PD Modification Application: MM 25-0133

Zoning Hearing Master Date: April 15, 2025

Development Services Department

AGENCY REVIEW COMMENT SHEET

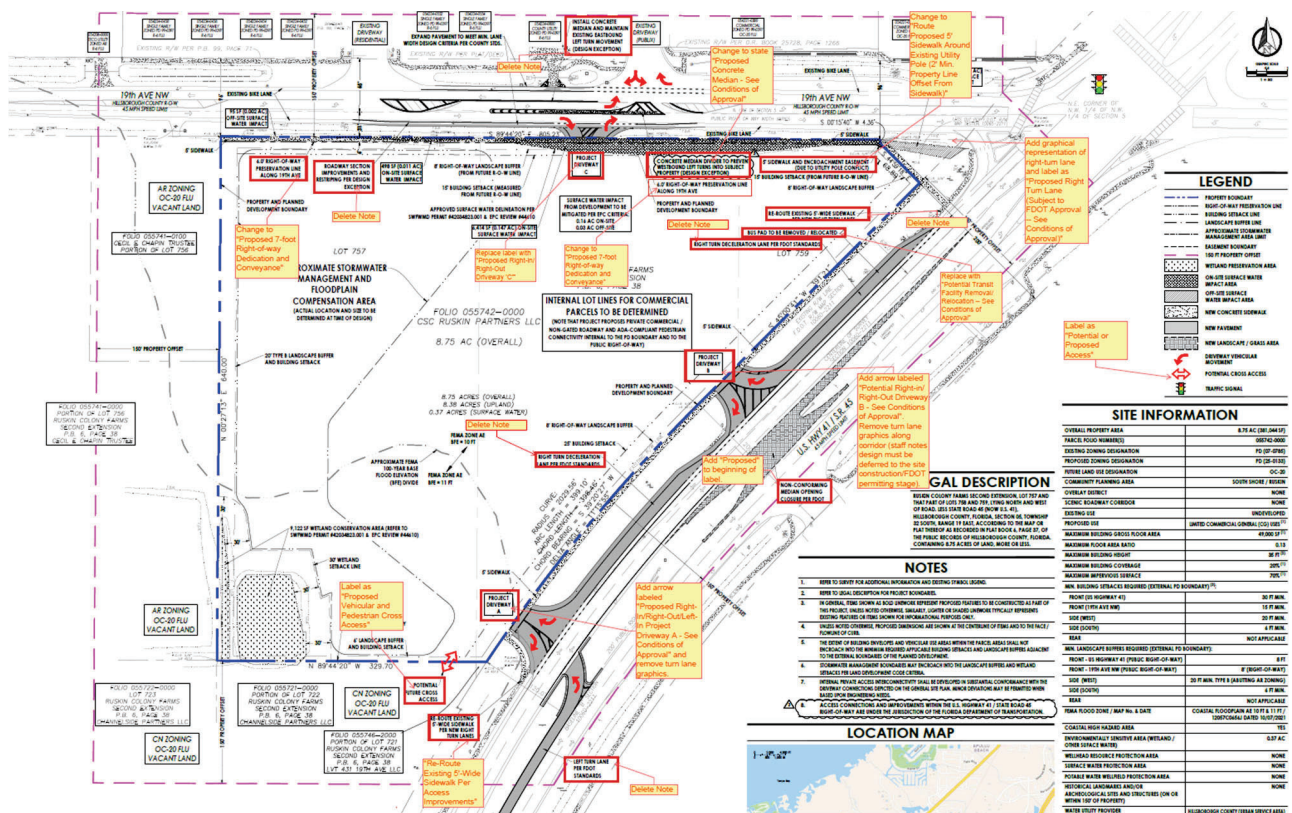
10. The Developer shall construct internal and external sidewalks ~~within the right of way along all roadways adjacent to the property boundaries and along both sides of all internal roadways. The sidewalks shall be a minimum width of five (5) feet~~ in accordance with the Hillsborough County LDC, Transportation Technical Manual (TTM) and other applicable rules and regulations. Pedestrian and vehicular interconnectivity shall be provided between uses ~~and adjacent parcels~~ within the PD. As shown on the PD site plan, the developer shall dedicate and convey 7-foot or right-of-way to the County to accommodate the required sidewalk along the project's 19th Ave. frontage. Shade trees shall be provided adjacent to all sidewalks. The developer shall donate sufficient right of way contiguous to 19TH Avenue for a 10-foot wide, bike/pedestrian shared paved

[Staff recommends modification of this condition to comport with current practice. Staff is proposing to strike those elements of the condition related to the trail and trail amenities, which the developer has requested be removed (and which are described further hereinbelow). Staff notes that sidewalk width is a function of LDC and/or Transportation Technical Manual requirements, and sidewalks within FDOT rights-of-way are also subject to their minimum width requirements. As such, staff has proposed to remove certain language in accordance with current practice to defer those design elements to the plat/site/construction plan review stage (which will be based on the regulations then in effect at the time of plat/site/construction plan review).]

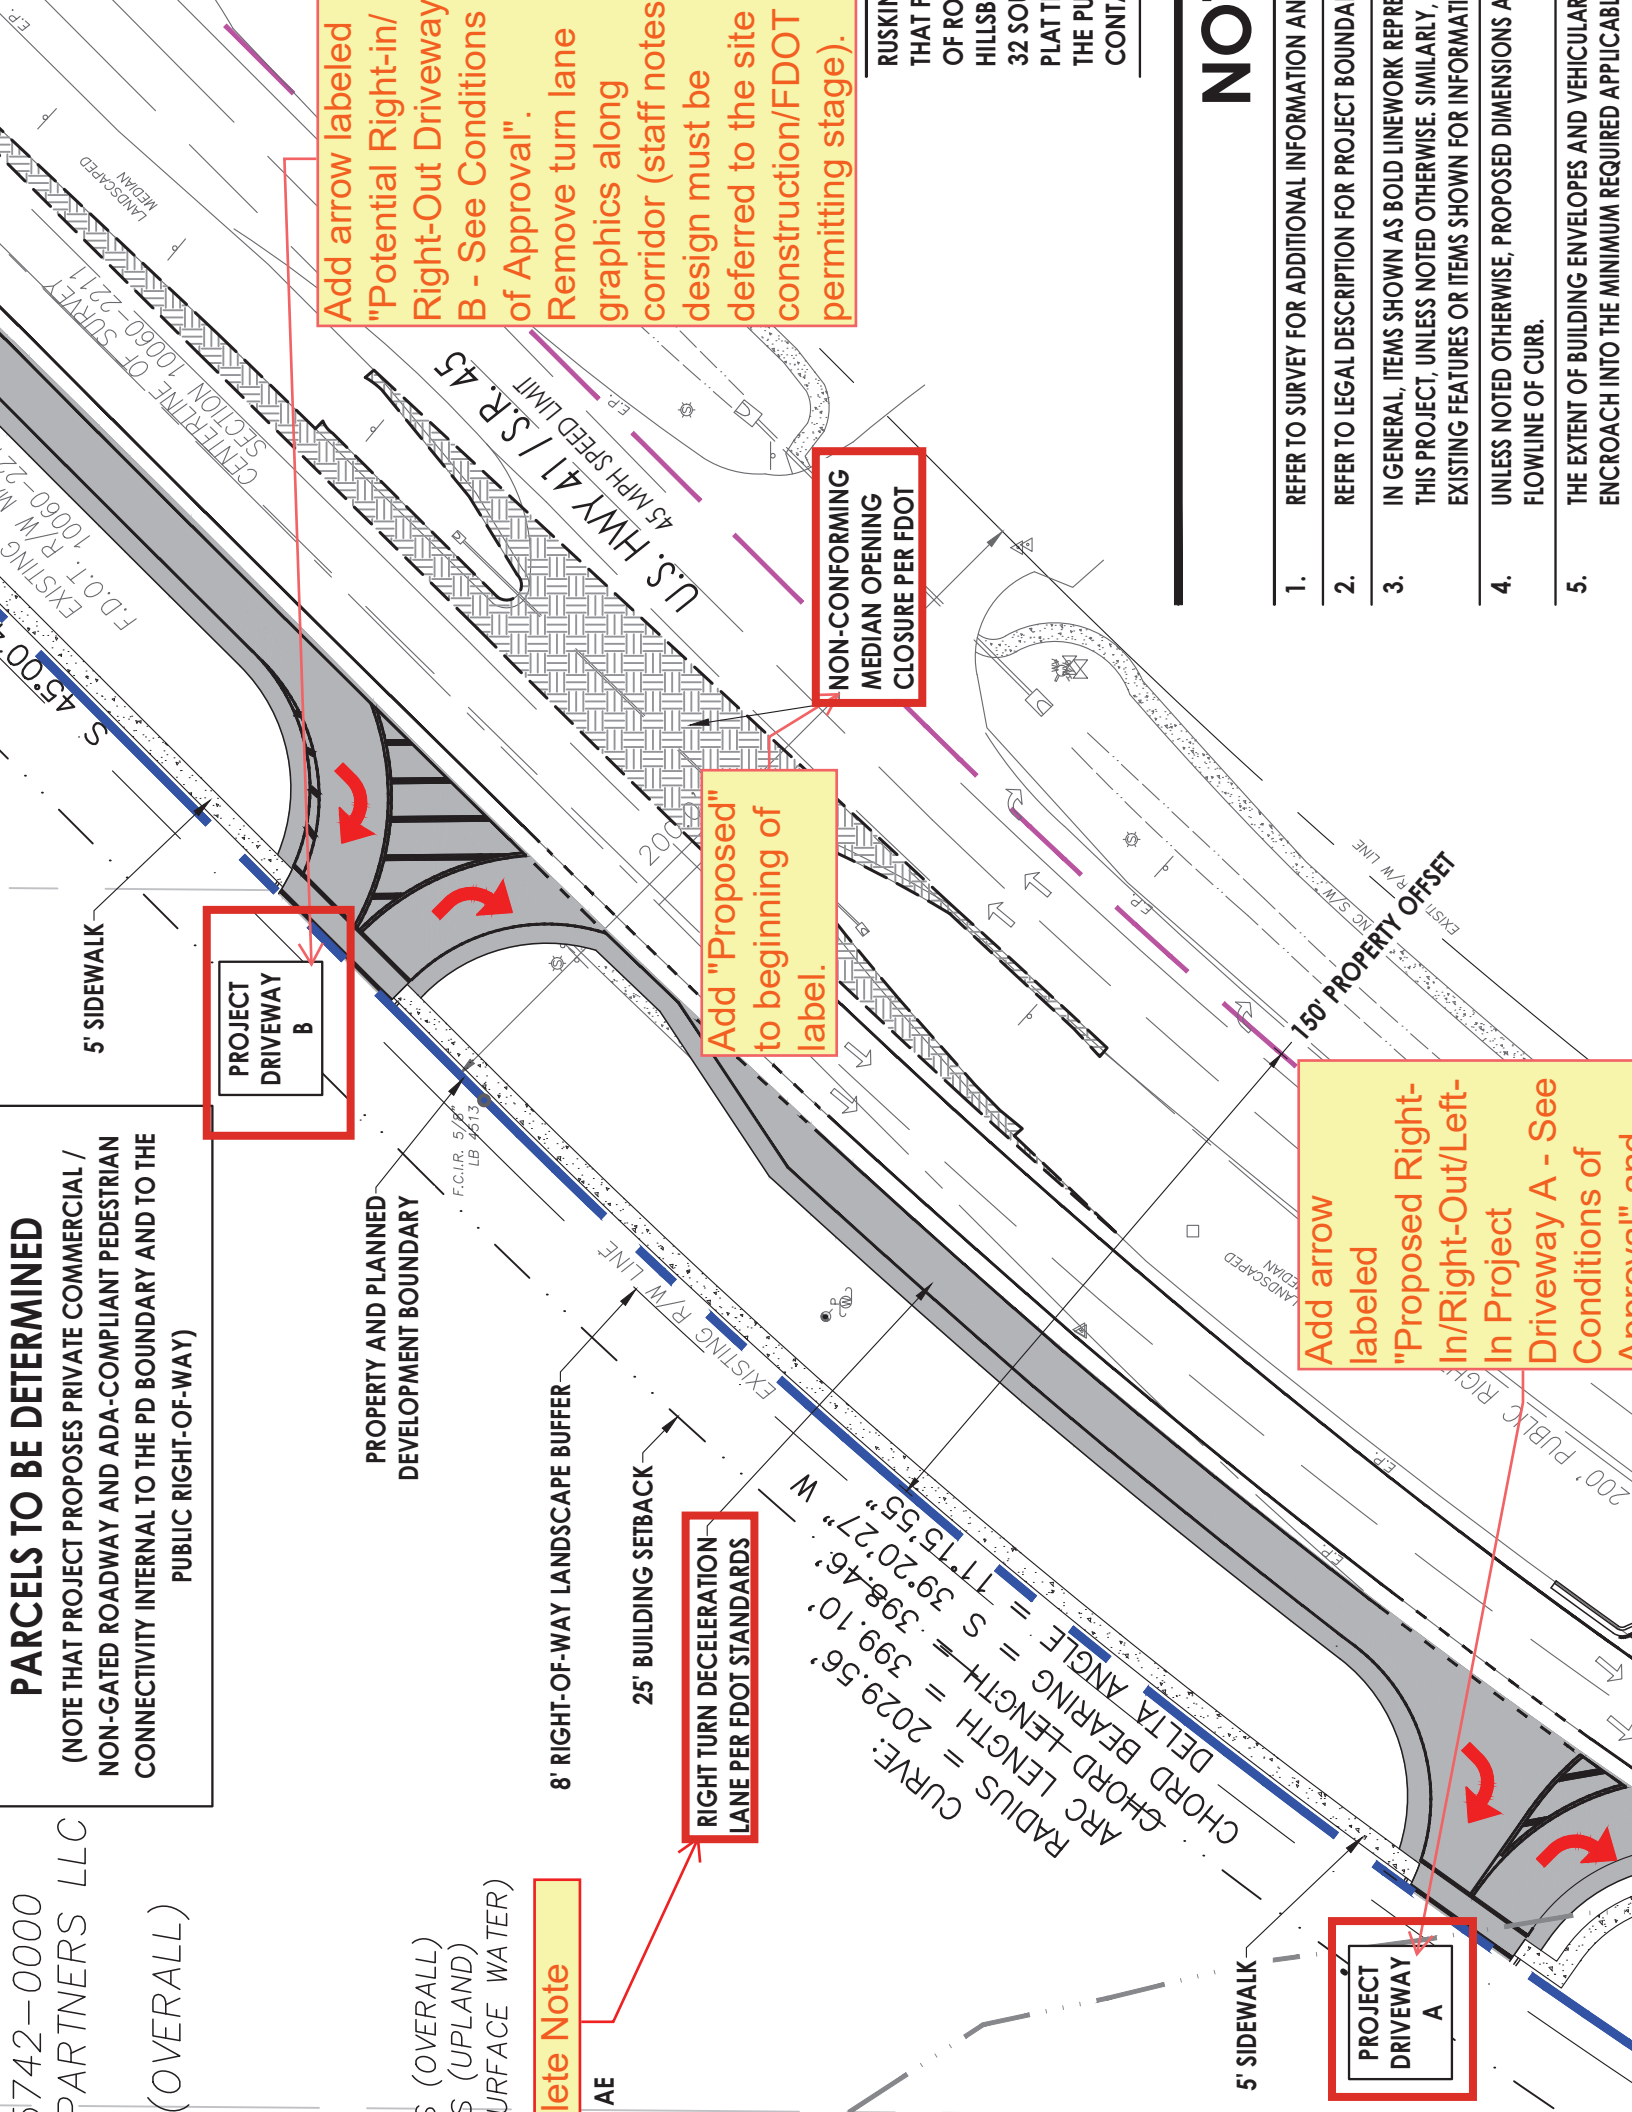
- Prior to PD site plan certification, the developer shall revise the PD site plan to make the PD site plan changes shown below (staff notes that an 24 x 36 sized copy has been appended to this report to aid legibility).

Add arrow labeled "Potential Right-in/Right-Out Driveway B - See Conditions of Approval".
Remove turn lane graphics along corridor (staff notes design must be deferred to the site construction/FDOT permitting stage).

Add "Proposed" to beginning of label.

Add arrow labeled "Proposed Right-In/Right-Out/Left-In Project Driveway A - See Conditions of Approval" and
